NAVIGATION - TRANSMITTAL OF COLLINS AEROSPACE SERVICE BULLETIN ALT-4000-34-14,
NAVIGATION - ALT 4000 POWER SUPPLY ROBUSTNESS IMPROVEMENT

SUBJECT: NAVIGATION - ALT-4000 - POWER SUPPLY ROBUSTNESS IMPROVEMENT

This is the initial release of Service Bulletin (SB) ALT-4000-34-14 for the ALT-1000 and ALT-4000 Radio Altimeter Transceiver.

Power Supply Circuit Card A2A4, CPN 828-2633-007, Resistor R12, Component Location Diagram
Figure 1 (Sheet 1 of 2)

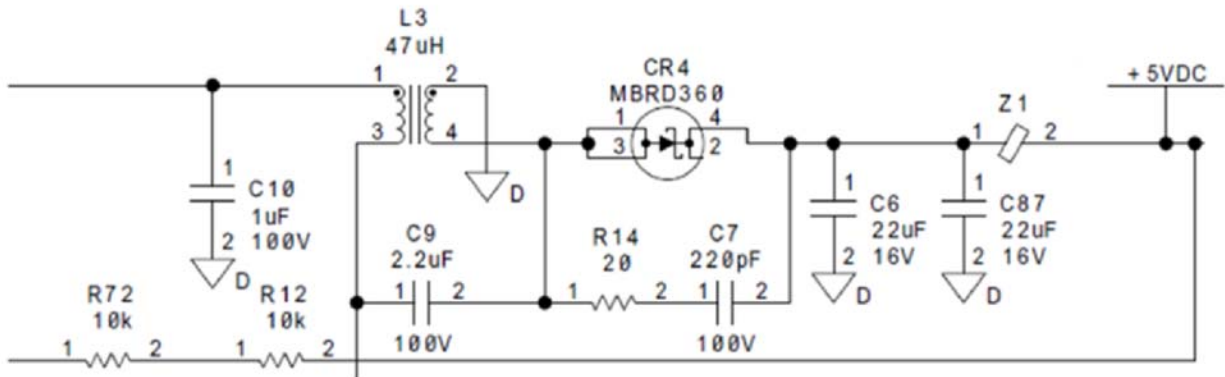
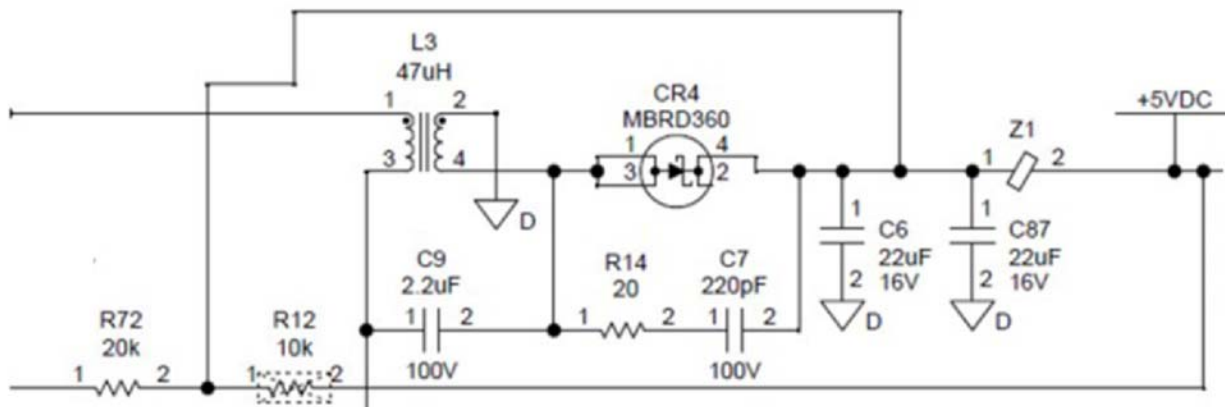
- (2) Locate, remove, and discard 10 Kilo Ohm (KOhm) resistor R12, CPN 705-2438-440, as shown in Figure 1.

Power Supply Circuit Card A2A4, CPN 828-2633-007, Resistor R72, Component Location Diagram
Figure 2 (Sheet 1 of 2)

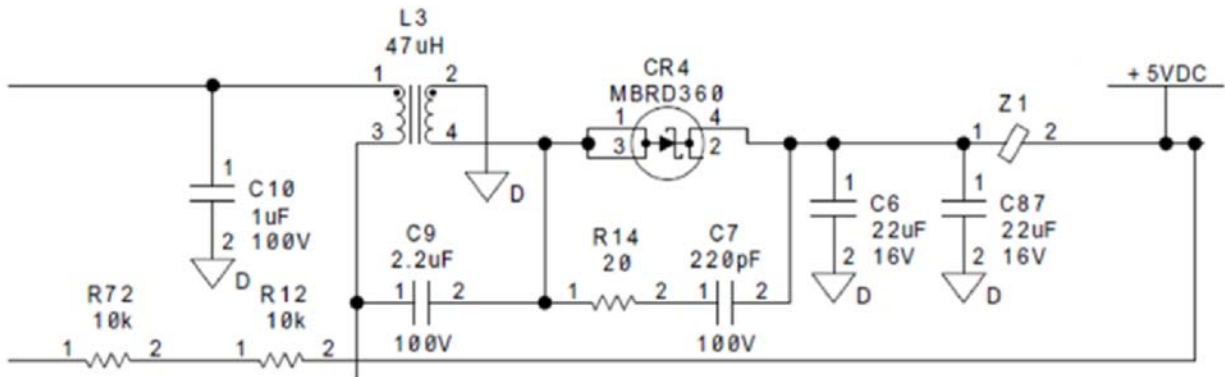
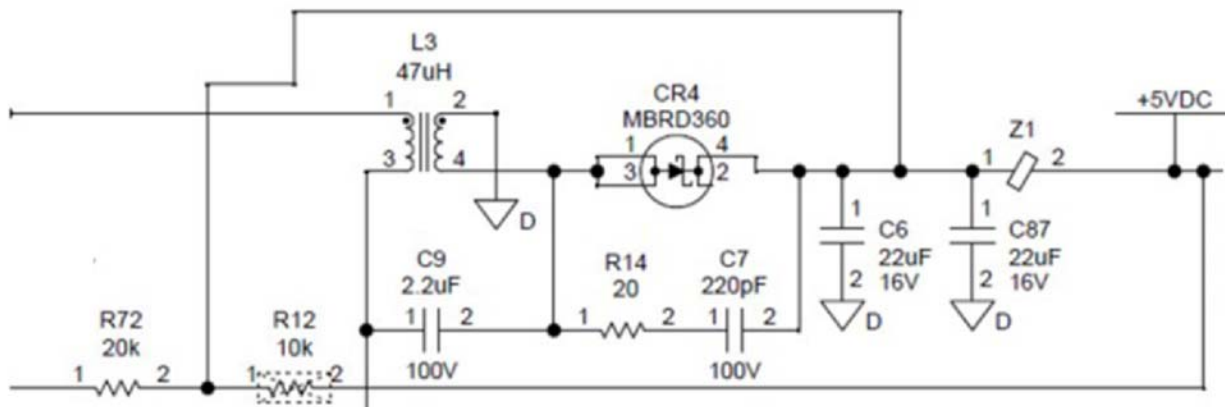
- (3) Locate, remove, discard, and replace 10 KOhm resistor R72, CPN 705-2438-440, with 20 KOhm resistor, CPN 705-2438-590, as shown in Figure 2.

Power Supply Circuit Card A2A4, CPN 828-2633-007, Jumper Wire Location Diagram
Figure 3 (Sheet 1 of 2)

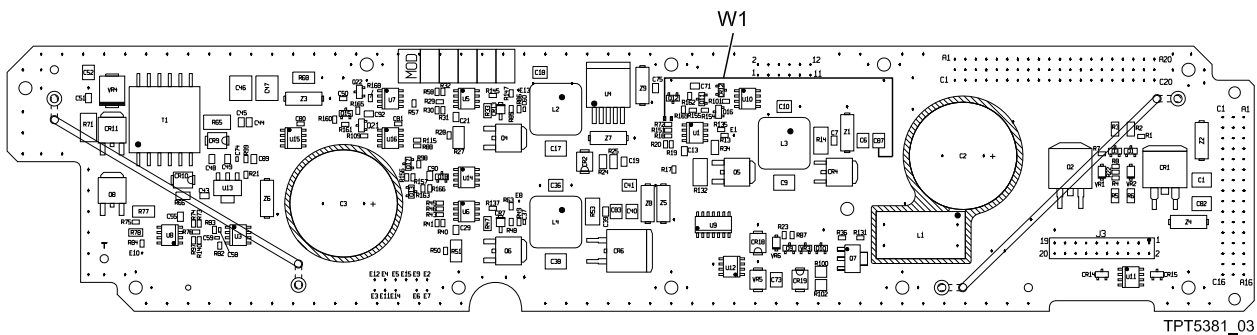
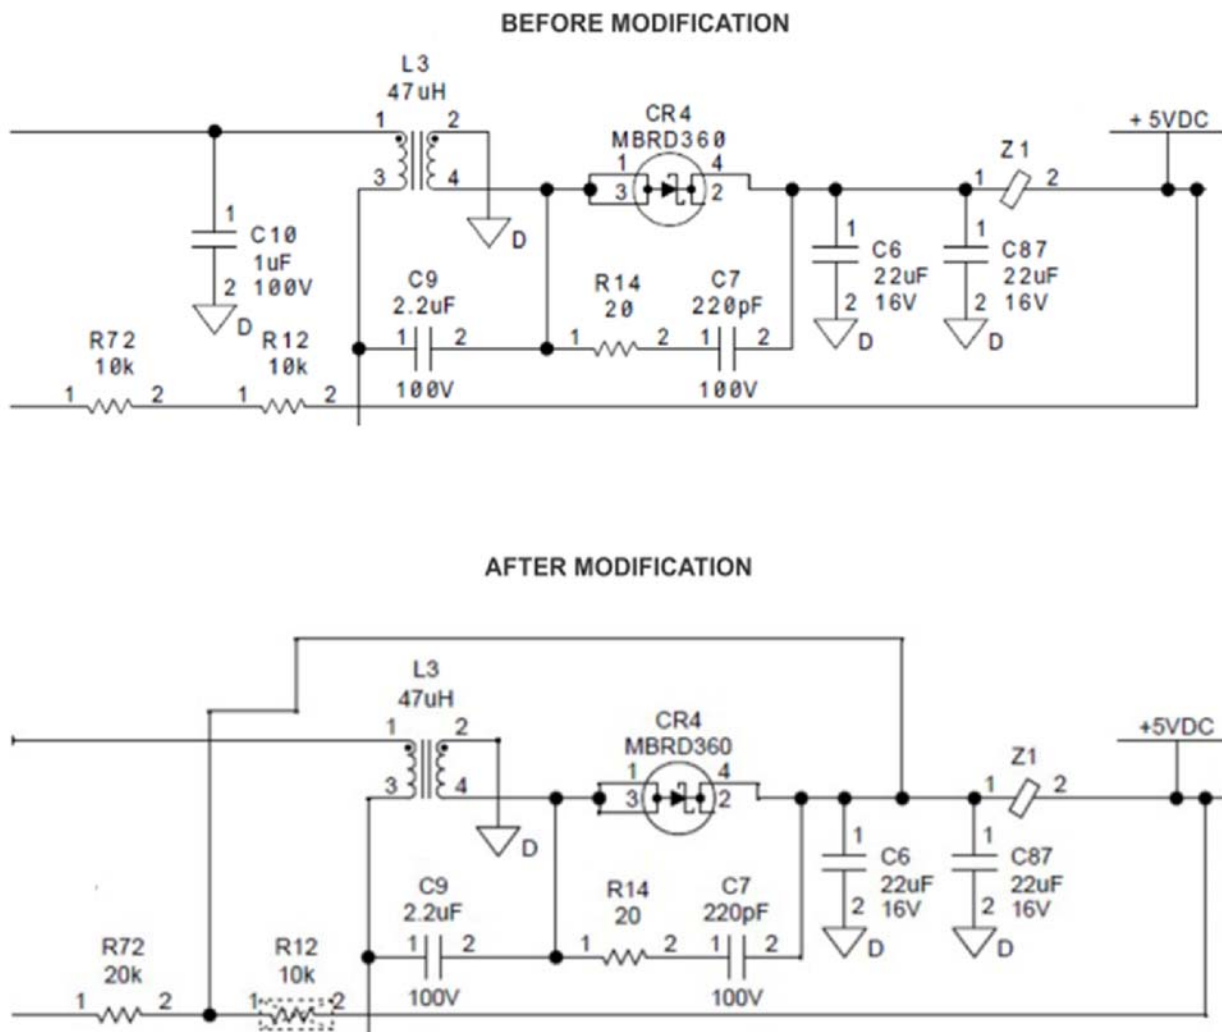
- (4) Install 30 gauge jumper wire W1, CPN 428-0282-050, from left pad of resistor R12, which was previously removed in Step 3.A.(2), to lower pad of capacitor C87 and bond with adhesive, CPN 005-0225-010. Apply a thin coat of adhesive, CPN 005-0225-010, for conductor bonding to the bottom side and perimeter of the pad (the conductor will be soldered) extending a minimum of 0.254mm [0.010 inch] beyond the outer edge of the pad/conductor(s) as shown in Figure 3 and Table 1.

NOTE: Avoid crossing over vias shown above routing and avoid crossing over screw holes when installing jumper wire.

Power Supply Circuit Card A2A4, CPN 828-2633-007, Marking Location Diagram
Figure 4

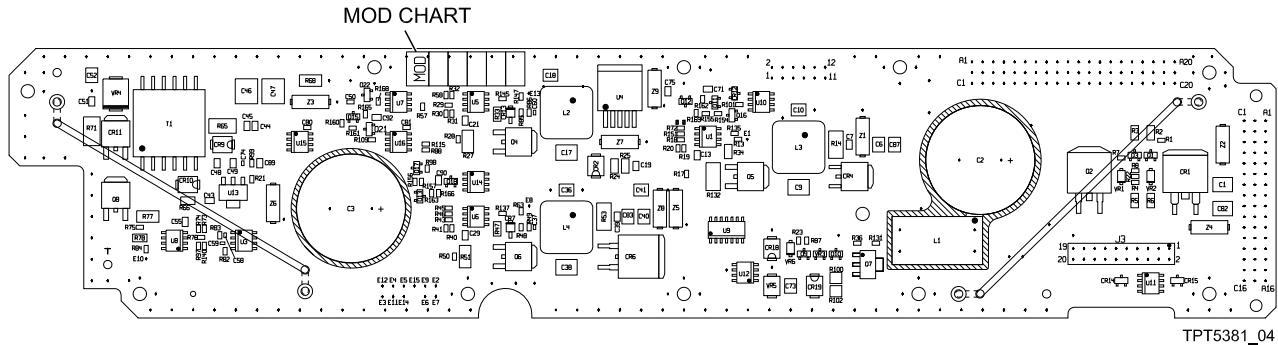
- (5) If MOD Chart, CPN 280-3778-110, is not already on the Power Supply Circuit Card A2A4, CPN 828-2633-007, then remove protective backing from MOD Chart, CPN 280-3778-110, and apply to circuit card in approximate location shown in Figure 4.

- (6) Use permanent ink to mark SB 14 on the MOD chart.
- (7) Reassemble the unit in accordance with the assembly instructions in the Assembly section of the referenced CMMPLs.
